## SERVICE BULLETIN

### NO. A361-71-2

Conversion Procedure To Convert Norco Inc. Strut Assembly A361-5 To A361-9

FIGURE 1

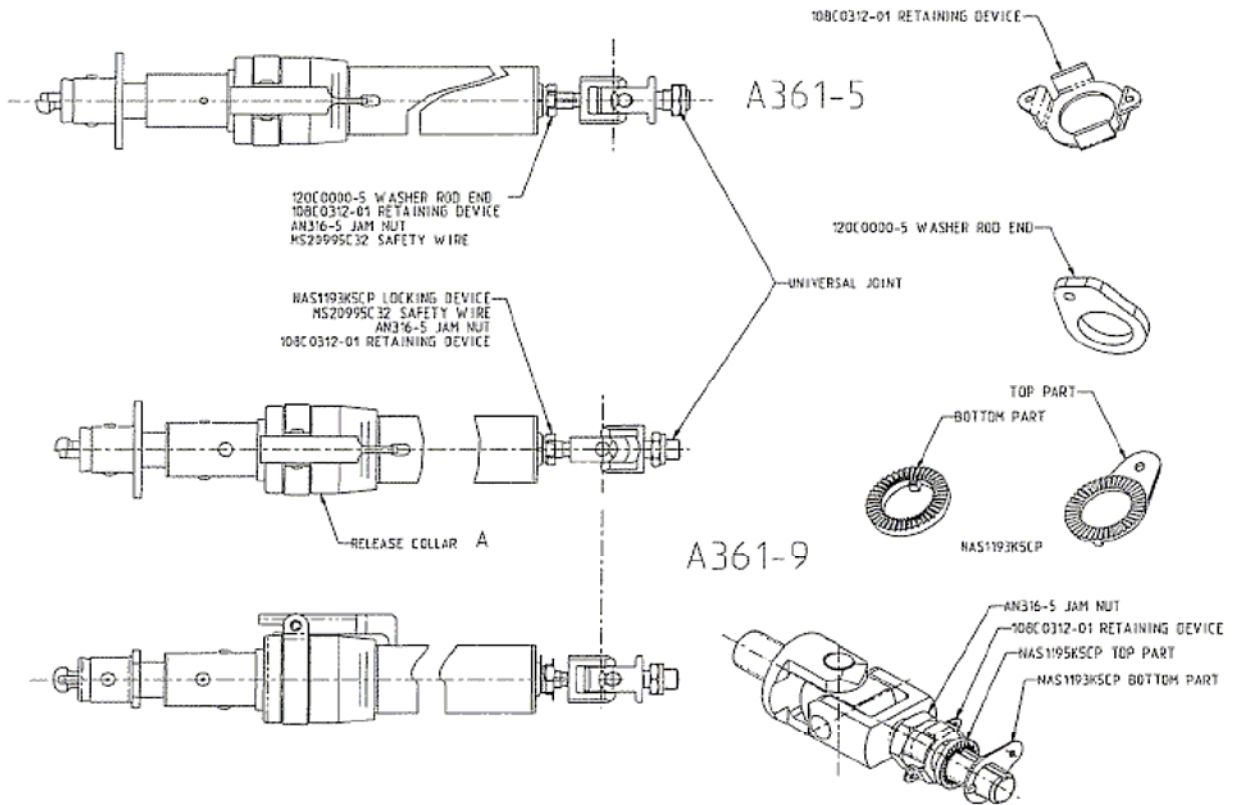
This Service Bulletin is to inform all users of the procedures and detailed instructions required for reworking Norco part number A361-5. The reworking requires reorientation of the universal assembly on the A361-5 to the orientation required on A361-9.

#### A. Disassembly (See Figure 1)

- (1) Cut safety wire MS20995C32 and discard.
- (2) Using a .500 open-end wrench, loosen jam nut AN316-5 approximately 4 turns by rotating counterclockwise.
- (3) Slide retaining device 108C0312-01 back with jam nut AN316-5.
- (4) Slide washer rod end 120C0000-5 back out of slot in strut end fitting.
- (5) Remove universal from strut assembly by rotating counterclockwise.
- (6) Discard washer rod end 120C0000-5 and retaining device 108C0312-01.

#### B. Assembly (See Figure 1)

- (1) Washer rod end 120C0000-5 is to be replaced with NAS1193K5CP locking device.
- (2) Replace jam nut AN316-5 and new retaining device 108C0312-01 on threaded shaft of universal.
- (3) Install bottom part of NAS1193K5CP so that internal key engages key slot in universal shaft with the serrations facing the end of the threaded shaft.
- (4) Position top part of NAS1193K5CP so that serrations are engaged with serrations on bottom part.
- (5) Engage threaded shaft of universal in threaded bore of strut end fitting.

- (6) Thread universal into strut end fitting by rotating clockwise.
- (7) Continue rotating until extended and locked length of  $43.00 \pm .06$  is obtained.
- (8) Adjust position of universal joint as shown on figure 1.
- (9) Engage key on top part of NAS1193K5CP with slot in strut end fitting
- (10) Engage serrations of bottom part with top part.
- (11) Rotate jam nut AN316-5 and retaining device 108C0312-01 together clockwise until contact with NAS1193K5CP is made.
- (12) Torque jam nut AN316C5 to 30/50 lb.-in.
- (13) Install new safety wire MS20995C32 in accordance with MS33540.
